# Access Compliance Report

## Public Rights-of-Way

Intersection ID: 23385	Main Street: GLENEAGLES_RD	Cross Street: WINGED_BOURNE	Location: SE
ADA ID: 9152FFE0C3F9	Ramp Type: PerpDiag	Initial Pass/Fail: Fail	Overall Compliance: No
Codes/Mitigation Info/Possible Solution		Field Measurements/Component Compliance

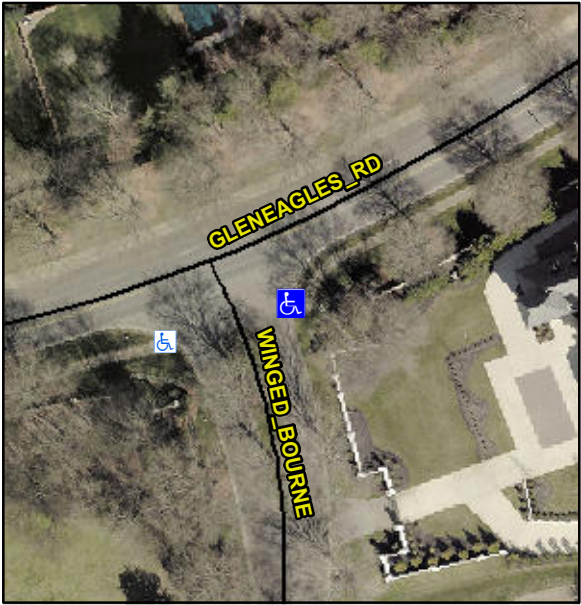
Possible Solutions:						
	Remove & Replace Curb Ramp With Two New Directional Ramps or Equivalent.						
	Surveyor Notes:						
	N/A						
	PROW/ADA:						
	Not Found, R304.5.1, R304.5.3						
Street 1 Name	GLENEAGLES RD	Compliance	Description	Data	Compliance	Description	Data
Stop Condition-Street 2	None	N/A	Ramp Length (in)	120.0	Yes	Ramp Slope (%)	6.5
Street 2 Name	WINGED BOURNE	No	Ramp Width (in)	43.0	No	Ramp XSlope (%)	3.4
Stop Condition-Street 1	StopSign	N/A	Flare Type LT	N/A	N/A	Flare Type RT	N/A
		N/A	Flare Slope LT (%)	N/A	N/A	Flare Slope RT (%)	N/A
		N/A	Flare Traversable LT?	N/A	N/A	Flare Traversable RT?	N/A
		N/A	Landing Length (in)	N/A	N/A	DWS Provided?	N/A
		N/A	Landing Width (in)	N/A	N/A	DWS Contrast?	N/A
		N/A	Landing Slope (%)	N/A	N/A	DWS Length (in)	N/A
		N/A	Landing X Slope (%)	N/A	N/A	DWS Full Width?	N/A
		N/A	Landing Curb? (Y/N)	N/A	N/A	DWS Offset (in)	N/A
		N/A	Shared Landing?	N/A
